# Access Compliance Report

## Public Rights-of-Way

| Intersection ID: 30070 | Main Street: SOUTHWIND_DR | Cross Street: WATERS_TRAIL_DR | Location: SE           |
| ADA ID: 3E38C6353DF5   | Ramp Type: PerpDiag       | Initial Pass/Fail: Pass       | Overall Compliance: No |

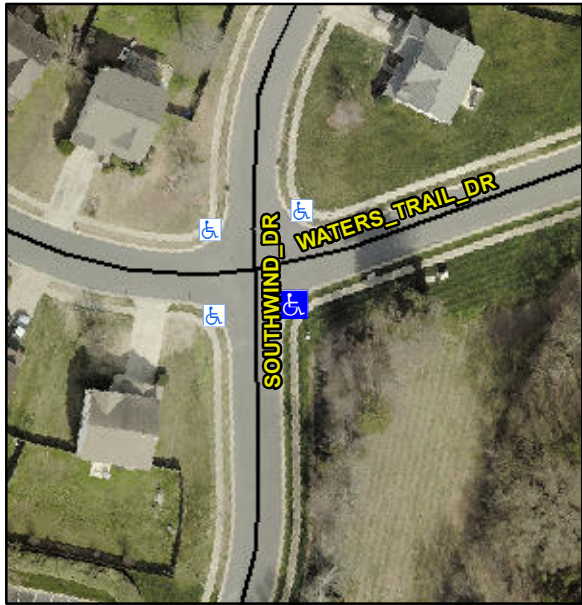
| Codes/Mitigation Info/Possible Solution  |  |  | Field Measurements/Component Compliance |                       |        |            |                             |      |
|--|--|--|---|-----------------------|--------|------------|-----------------------------|------|
|  |  |  | Yes                                     | Ramp Width (in)       | 48.0   | No         | Ramp XSlope (%)             | 2.5  |
|  |  |  | No                                      | Landing Length (in)   | 45.0   | Yes        | DWS Provided?               | Yes  |
|  |  |  | No                                      | Landing Slope (%)     | 2.6    | Yes        | DWS Length (in)             | 24.0 |
| Surveyor Notes:  |  |  | N/A                                     | Landing Curb? (Y/N)   | No     | No         | DWS Offset (in)             | 3.0  |
| Not Found, R304.5.3, R304.2.1, R304.2.2-Perp, R304.3.2-Para, R305.2              |  |  | Yes                                     | Gutter Ponding?       | No     | Yes        | Gutter Slope (%)            | 3.0  |

| Codes/Mitigation Info/Possible Solution  |  |  | Field Measurements/Component Compliance |                       |        |            |                             |      |
|--|--|--|---|-----------------------|--------|------------|-----------------------------|------|
|  | Remove & Replace Curb Ramp With Two New Directional Ramps or Equivalent. |  | N/A                                     | Ramp Length (in)      | 47.0   | Yes        | Ramp Slope (%)              | 6.4  |
